Title: State Street Campus Garage Mixed-Use project

State Street Campus Garage Mixed-Use project  
415 N. Lake Street, Madison, WI 53715  
Land Use – UDC change in zoning from UMX to PD (GDP-SIP).  
EUA Project Number: 720448-01

## **Revised Content Addressing Comments Made by the Urban Design Commission**

**1 LANDSCAPE PLAN**  
L 1.0 1" = 10'-0"

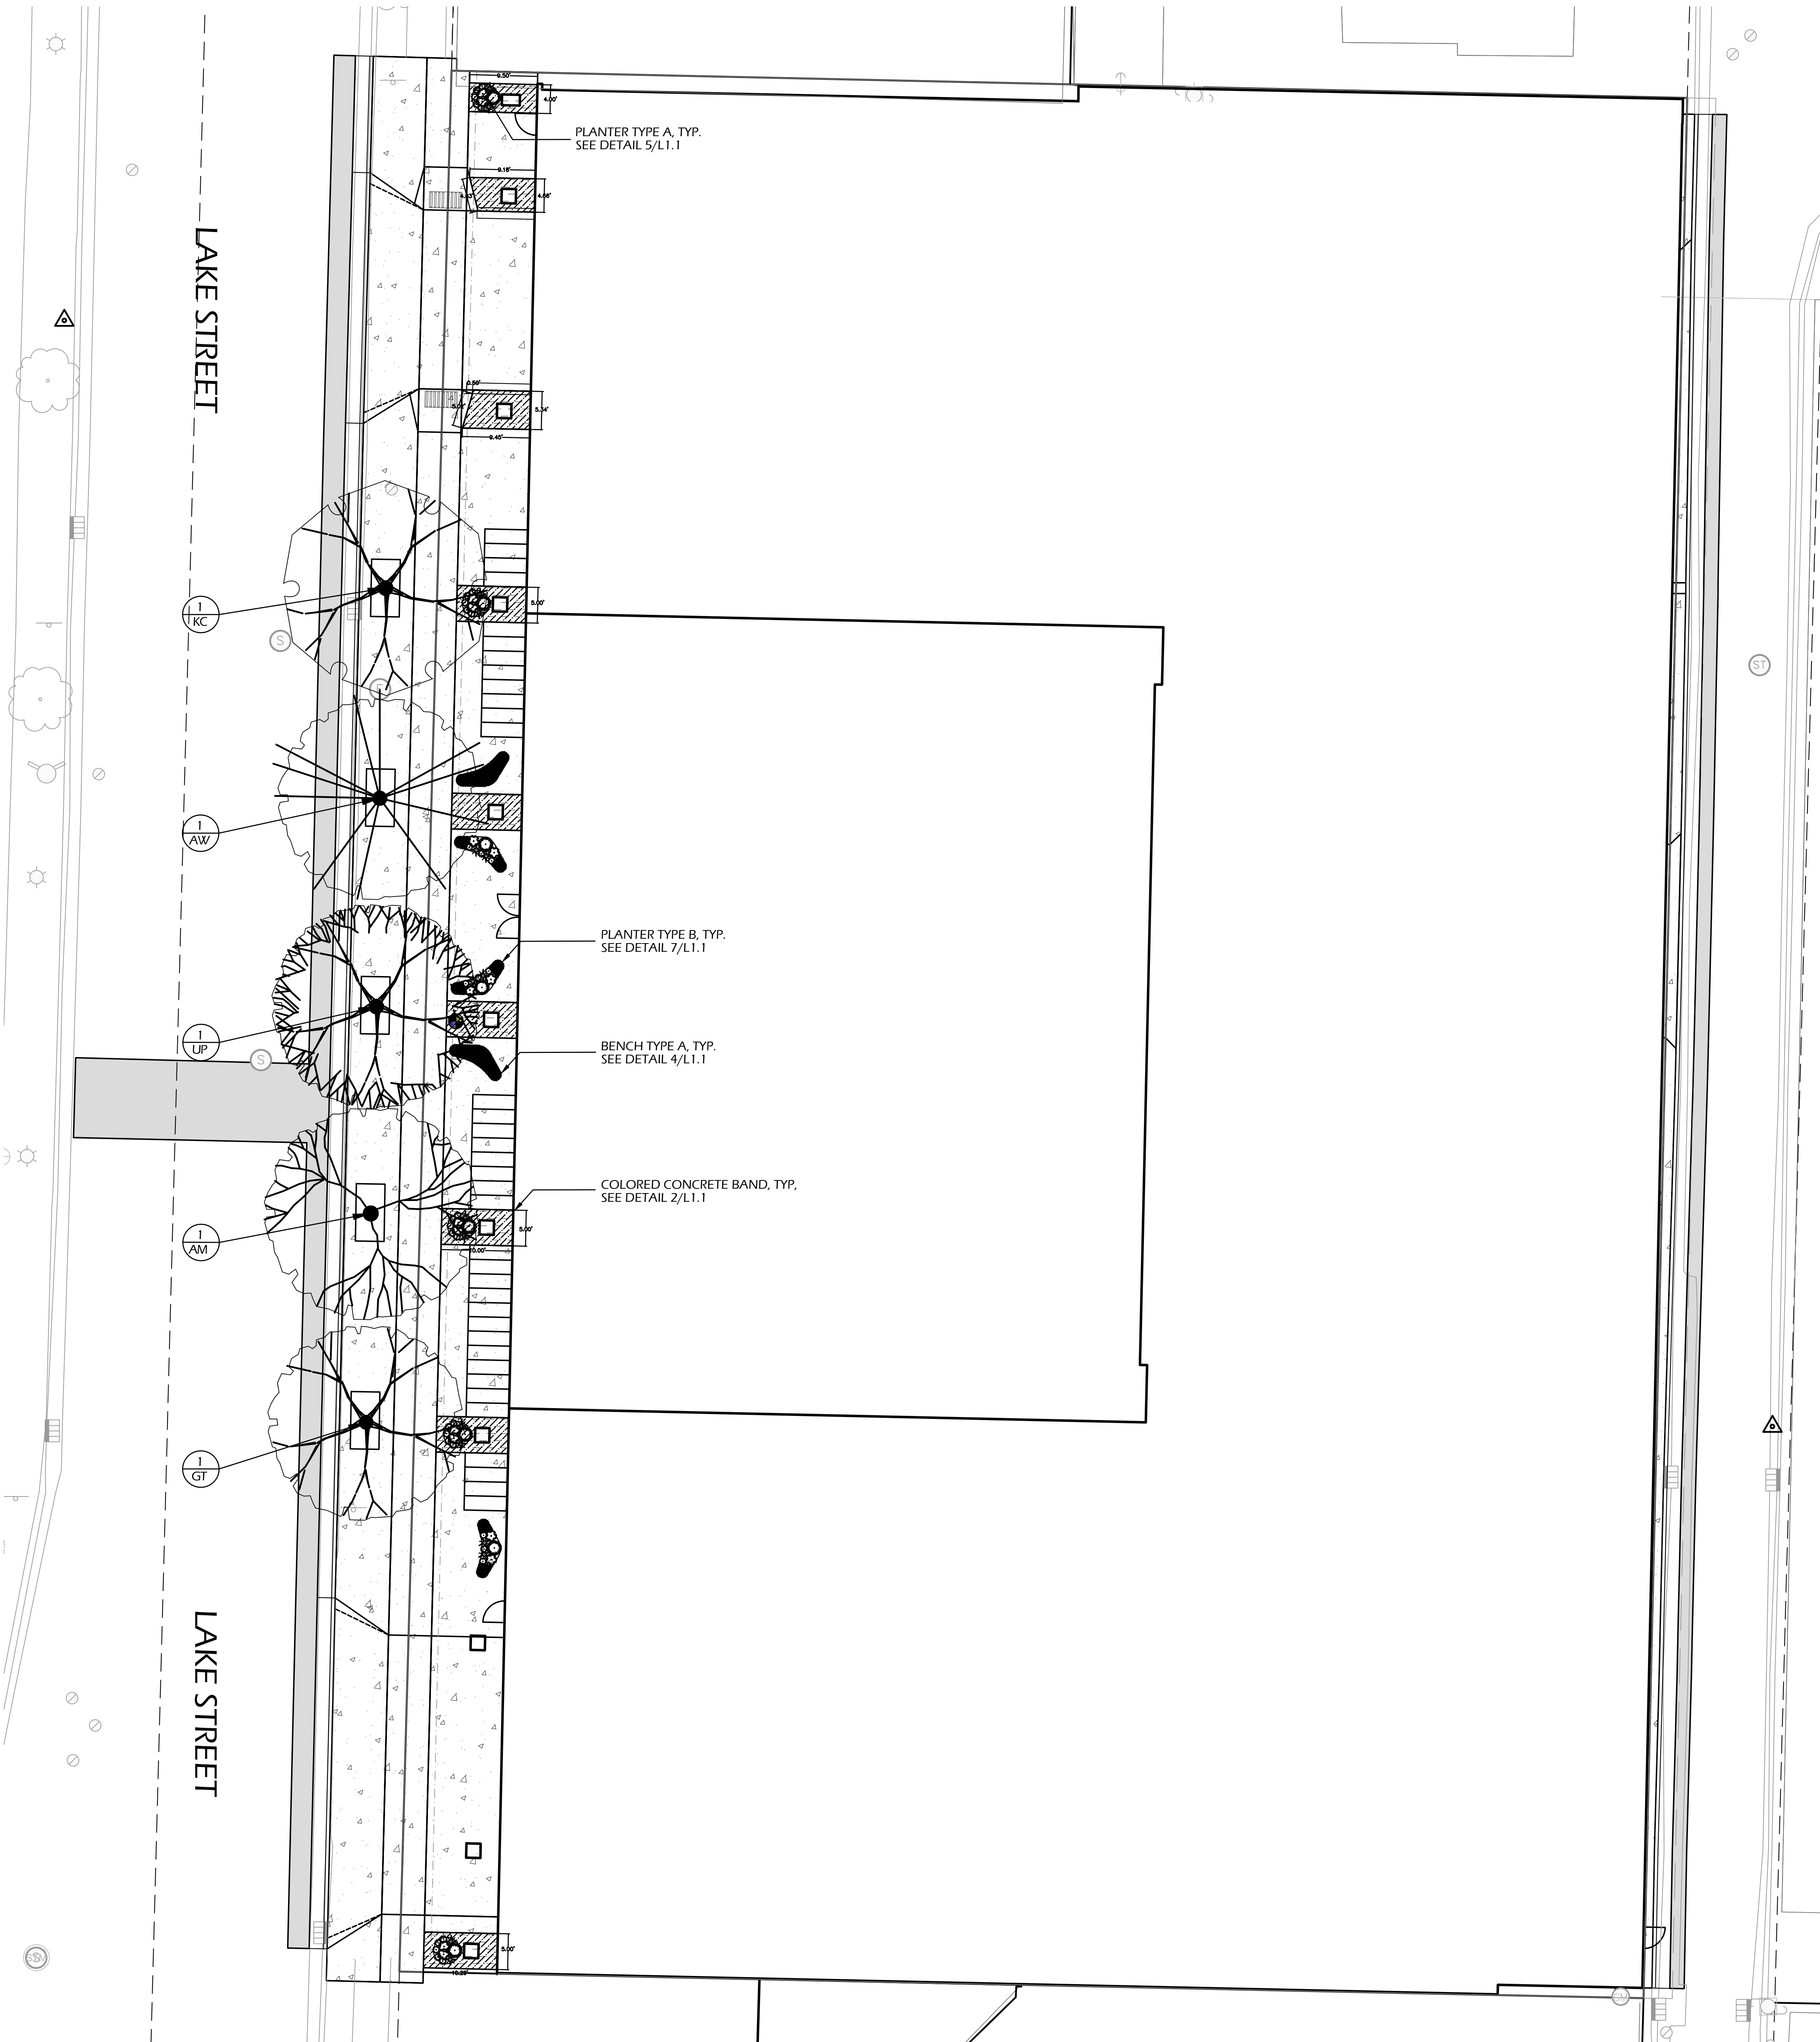
(Incorporate more substantial planting along Lake Street).

- Added two (2) additional Type A planters (planter size increased from 24" diameter to 44" diameter) and One (1) additional Type B planter with additional plantings on Lake Street. This increased the landscape points from 142 to 208.  
**(See Sheets L1.0 and L1.1)**

1 SOUTH ELEVATION  
1/16" = 1'-0"

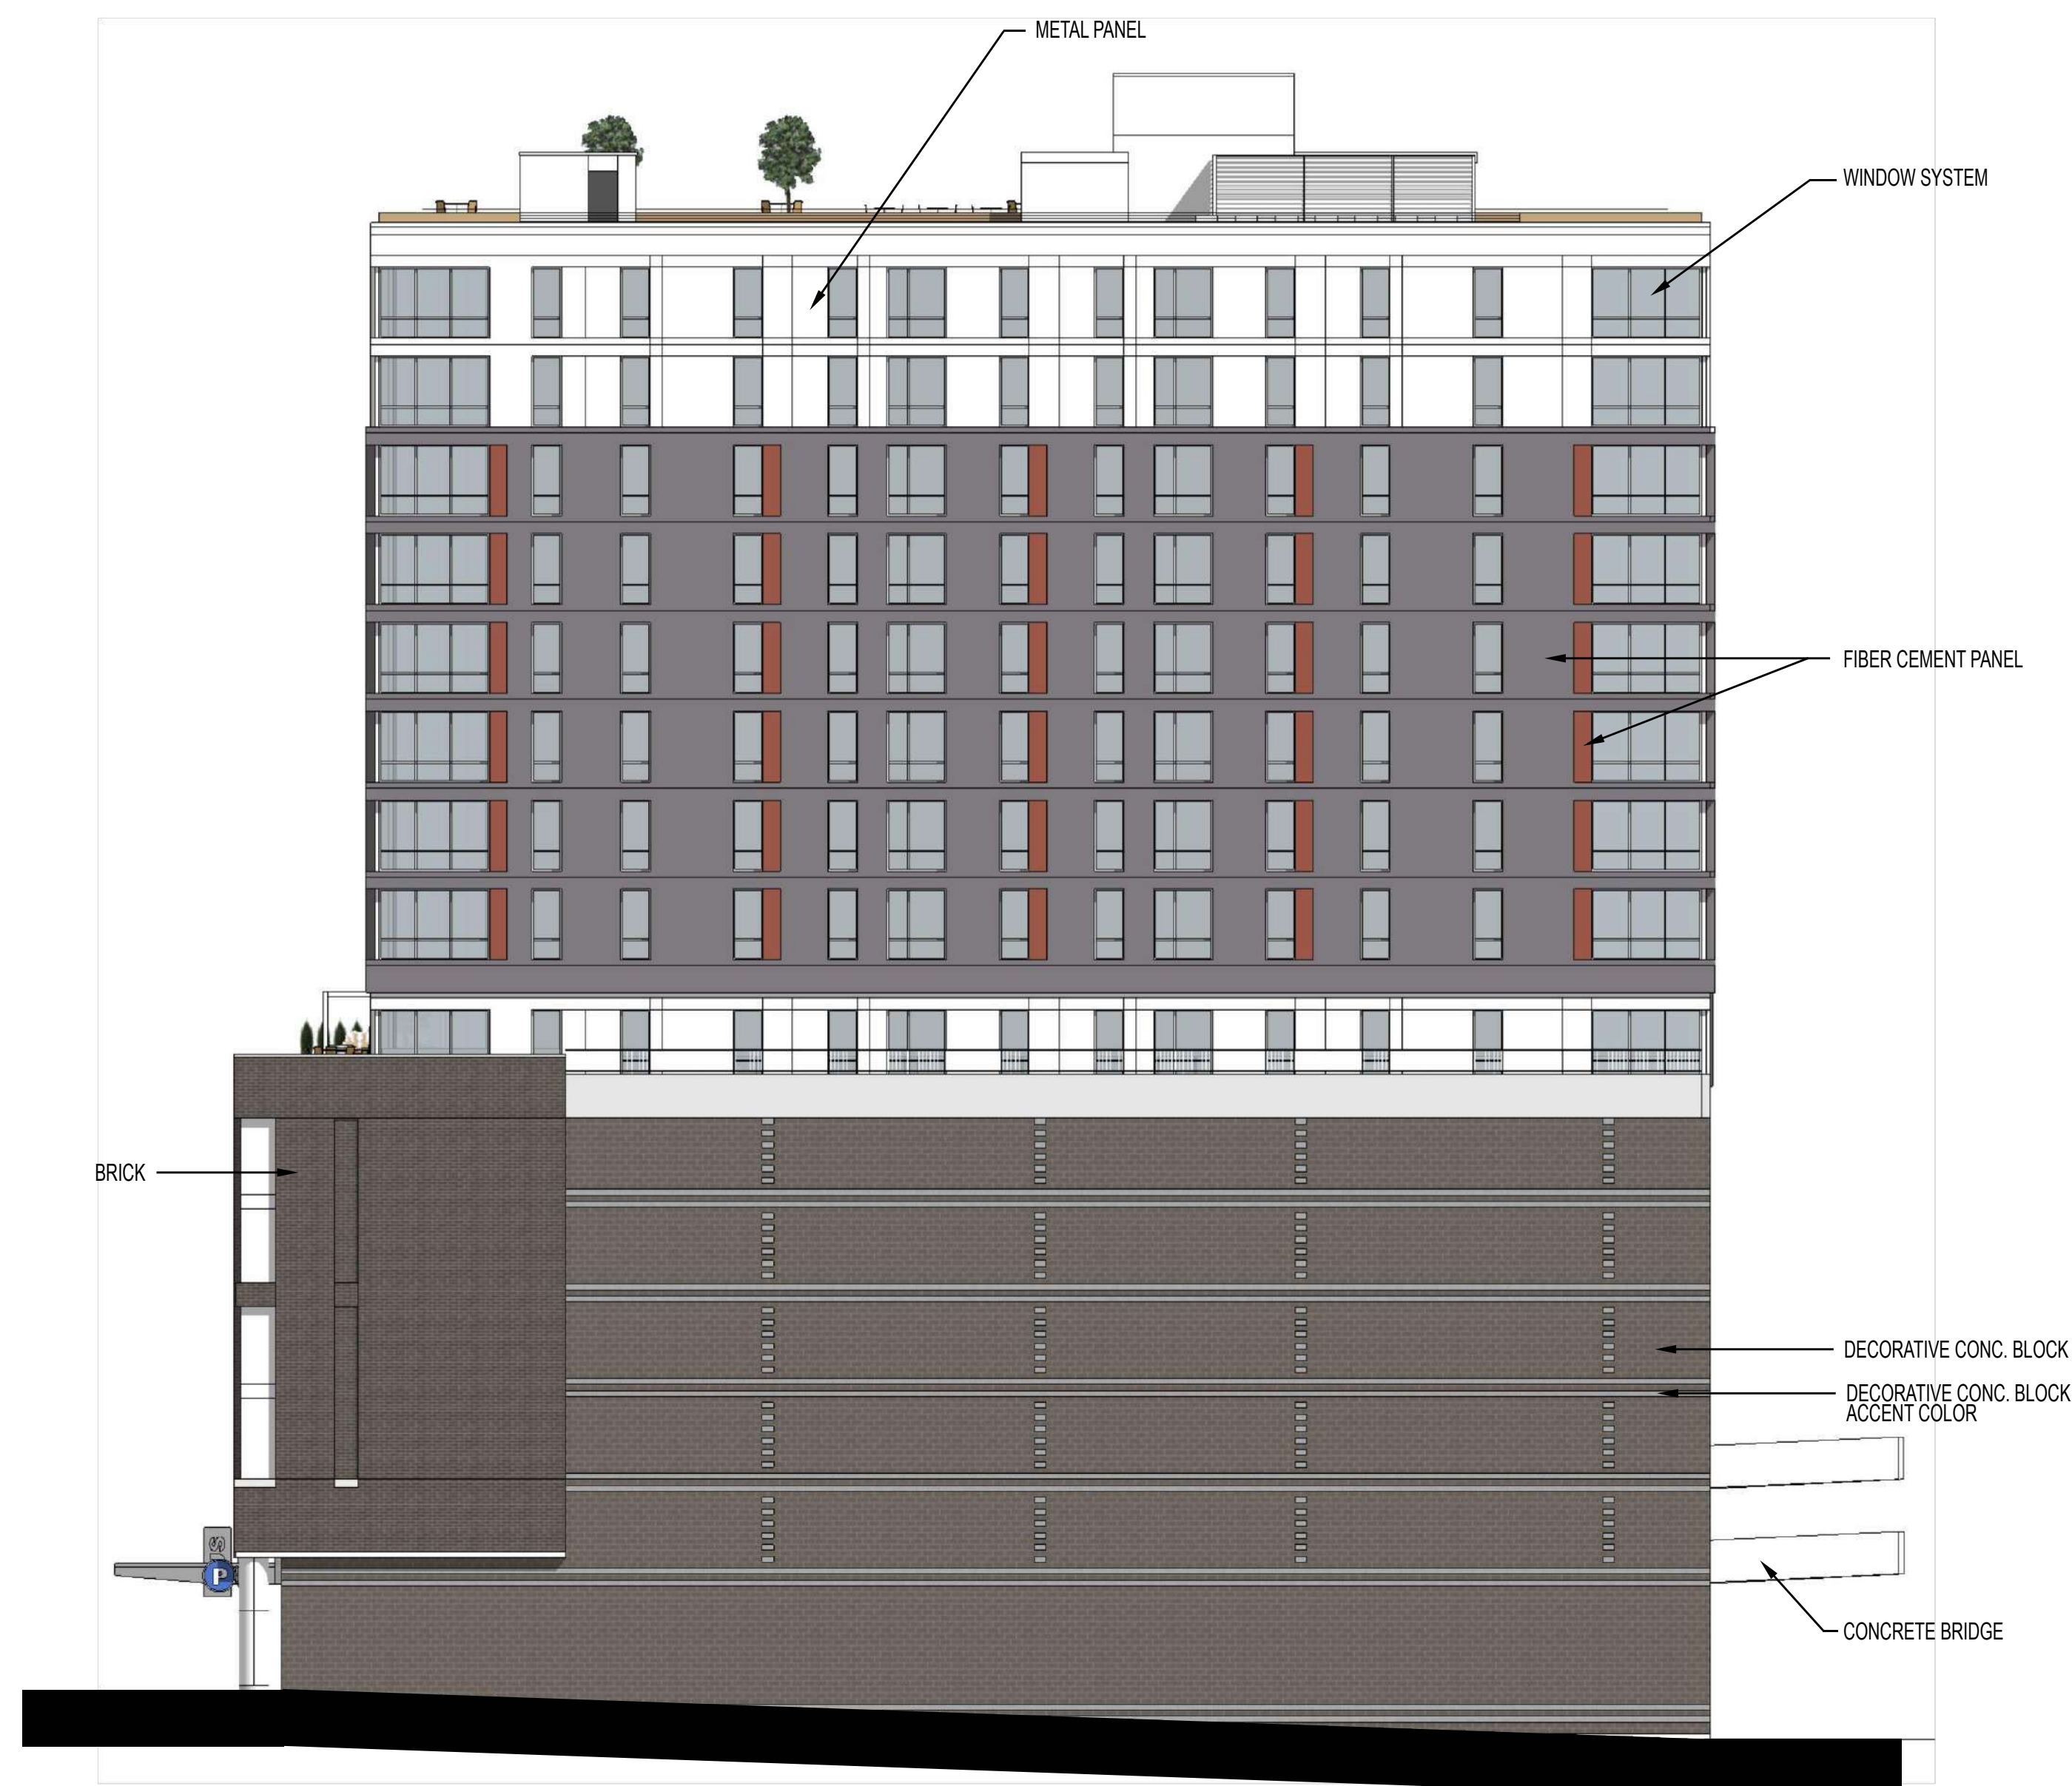
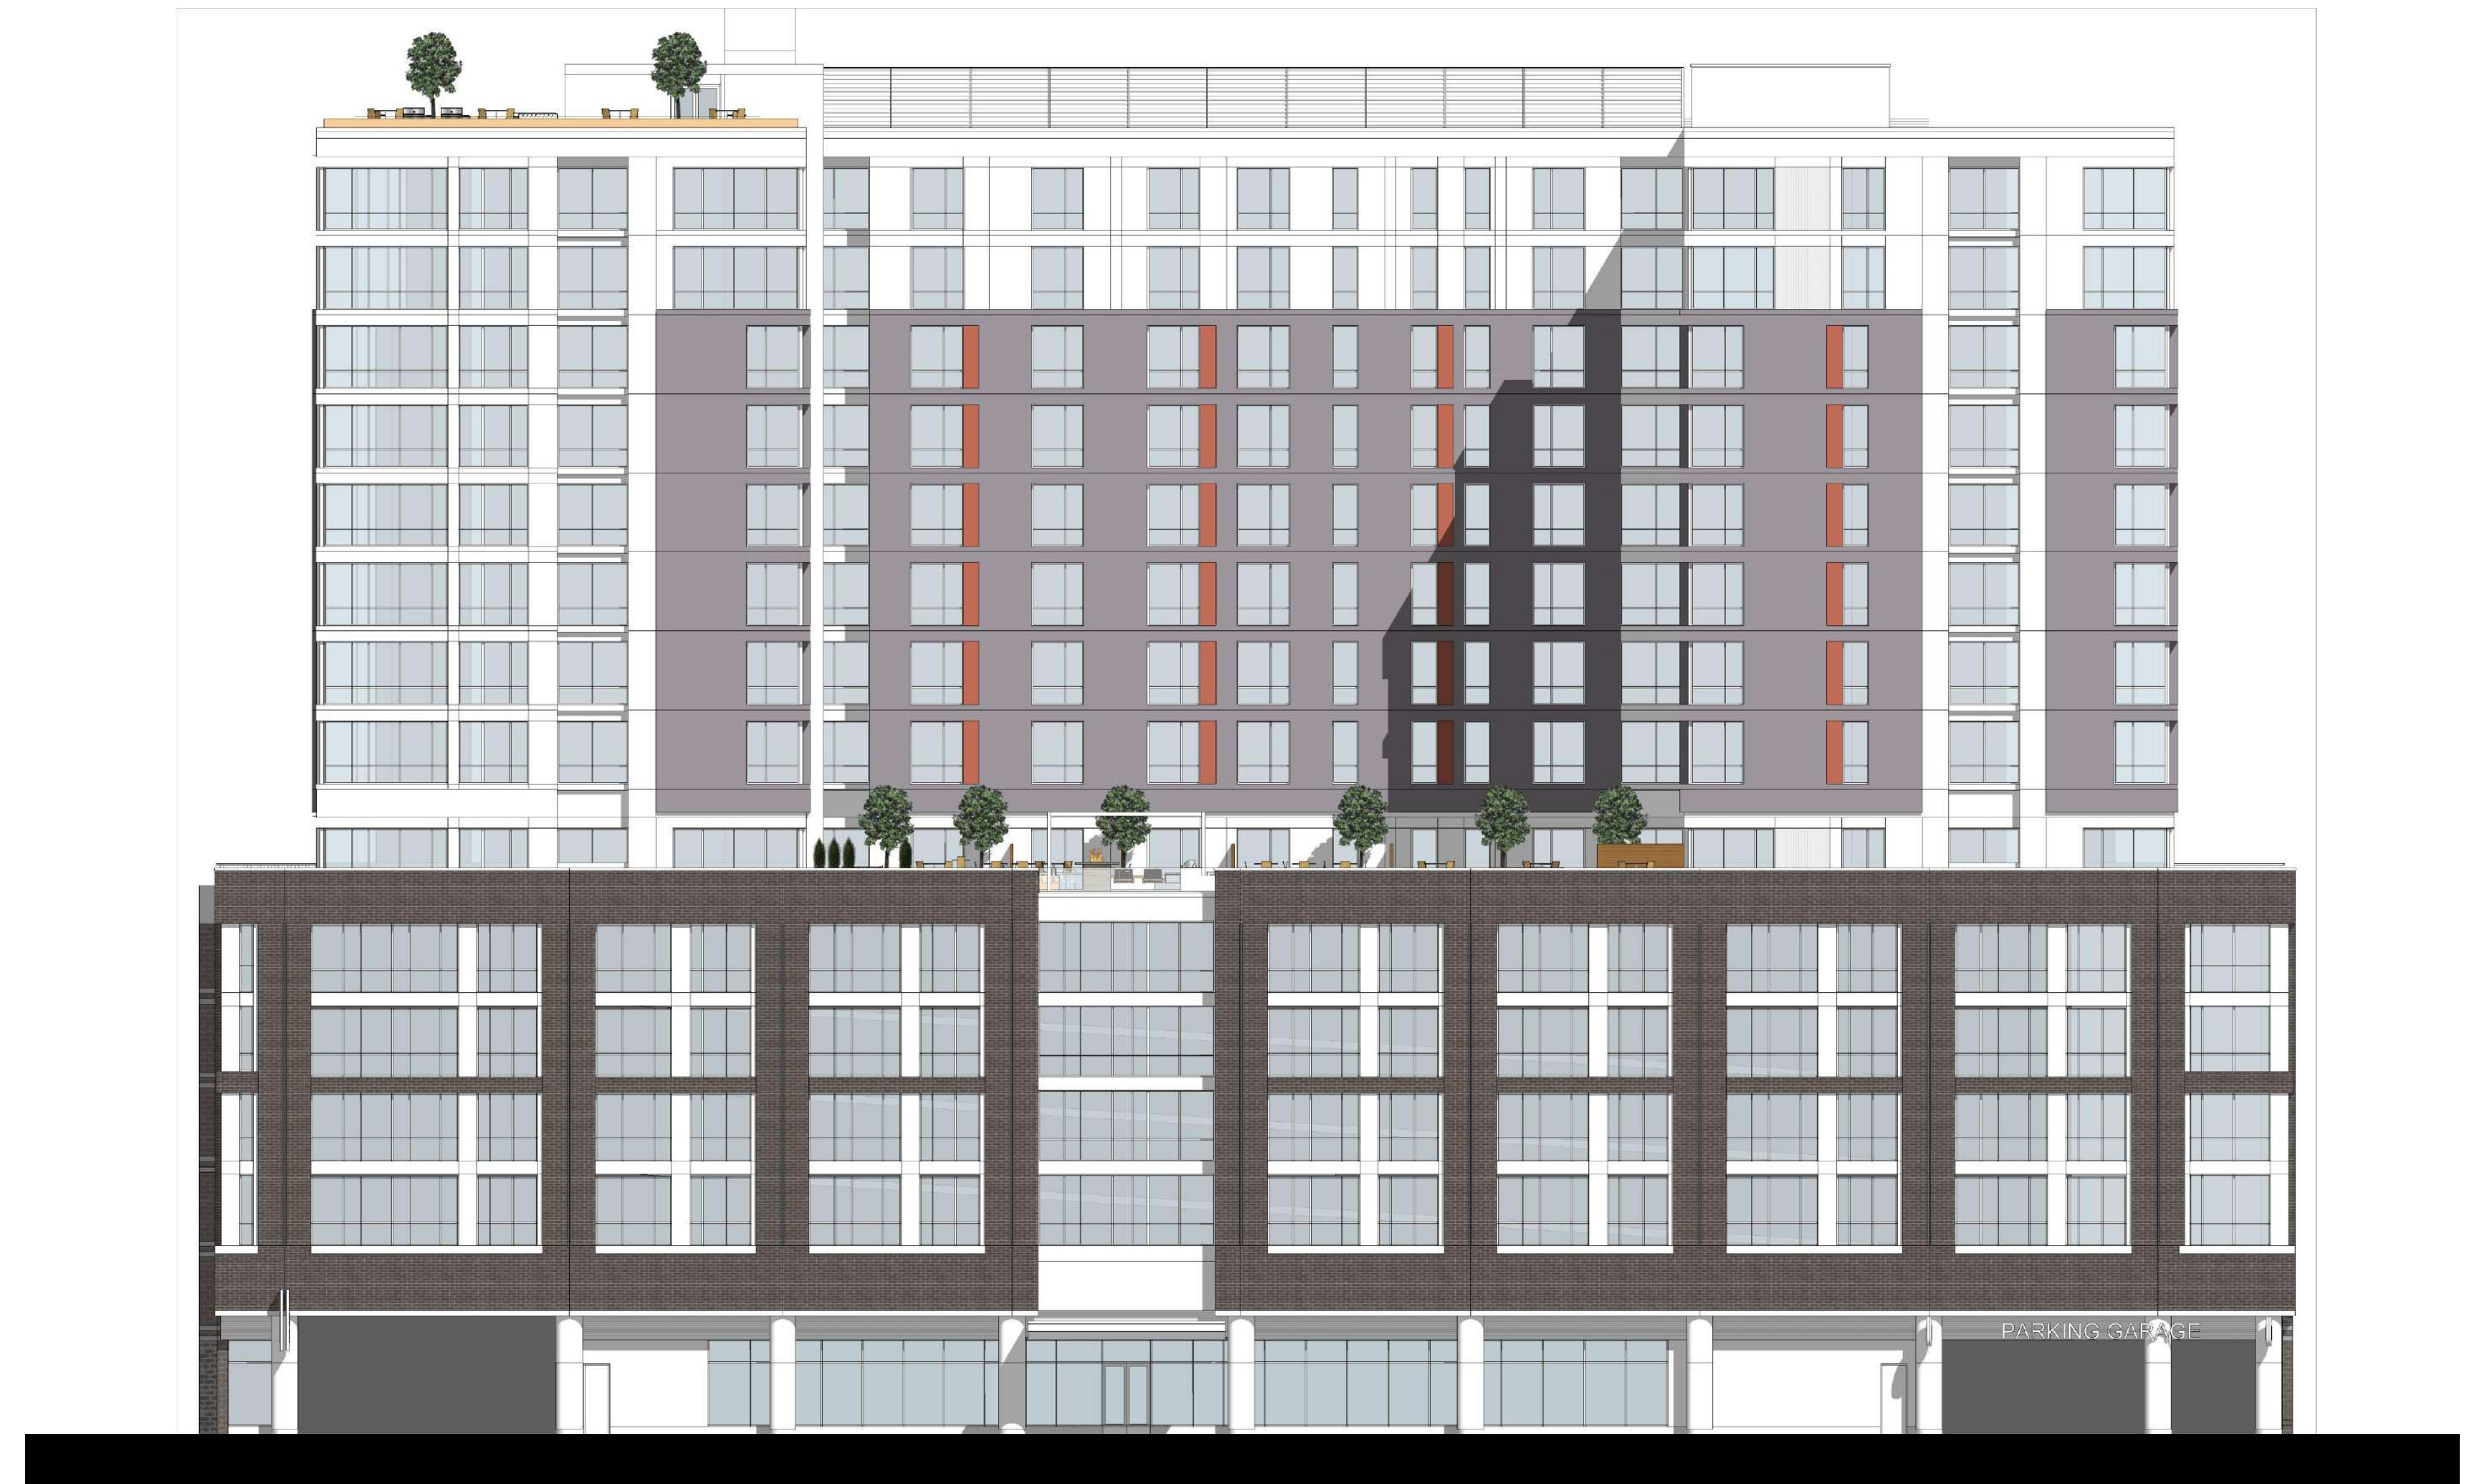
(Provide refinement of the level of design/articulation at the building corners and North/South elevations along Hawthorne Court and the exposed garage walls).

- Added design and material articulation to the north and south elevations.  
**(See Sheet A200)**
- The Hawthorne Court elevation will utilize the same burnished block that is being used on the other elevations. The two-colored block design feature on the north and south elevations will be utilized on the block areas of this elevation.  
**(See Sheet A200)**
